**MERPAC – March 16-17, 2016 – Jacksonville, FL**  
**Report on NMC’s Databases of Questions**  
**by**  
**Richard Plant,**  
**President, LAPWARE, LLC**

## MERPAC – March 16-17, 2016 – Jacksonville, FL

## ADDED COMPLAINT ABOUT NMC'S OPERATIONAL CHART PLOTS

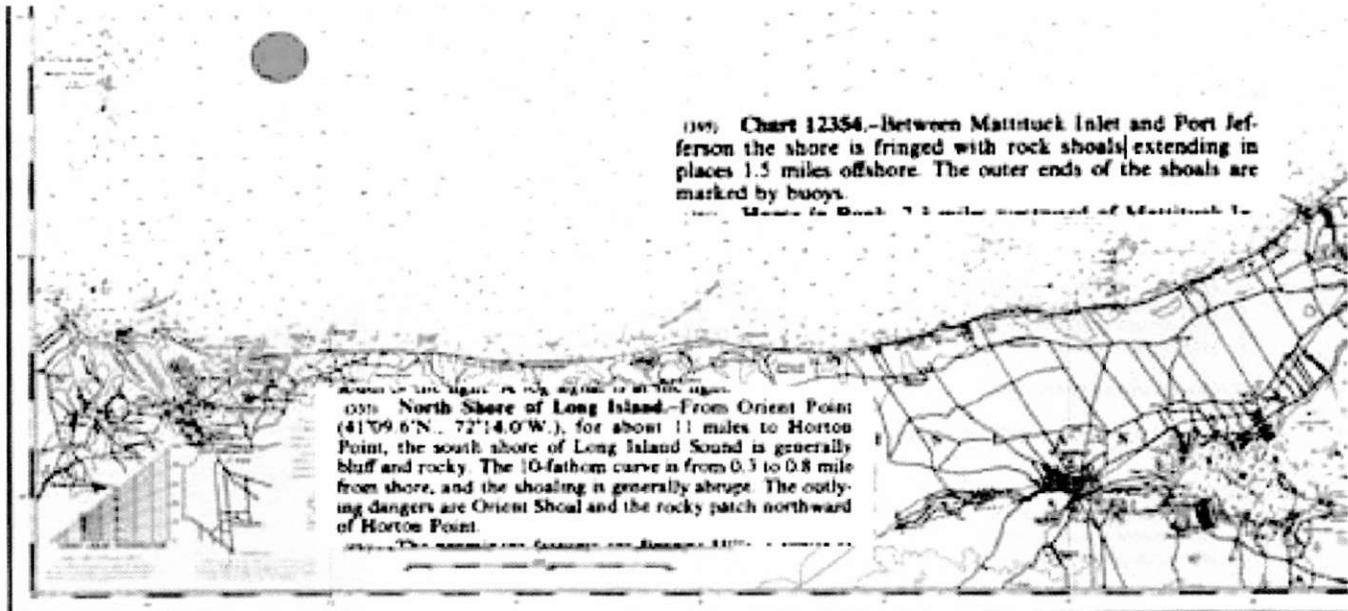
Chart Plots - Operational Level - Eastern Long Island Sound - there are FOUR plots that ask the same question. Basically the mariner is first asked to plot a position at 41 04.9'N and 73 01.1'W. The RED oval is the approximate position. NEXT each of the chart plots asks the same question. That is: "The south shore of Long Island Sound near your position is \_\_\_\_\_."

THREE of the keyed answers are "bluff and rocky" which is shown in the Coast Pilot under "North Shore of Long Island" where one would be expected, based on the question stem, to find their answer. NOTE that the mariner's position is just north of Port Jefferson. YET a FOURTH question has a keyed answer of "fringed with rock shoals". That answer is found looking up the Coast Pilots between **Mattituck Inlet and Port Jefferson**. Mattituck Inlet is on the FAR RIGHT of this copy of the chart above.
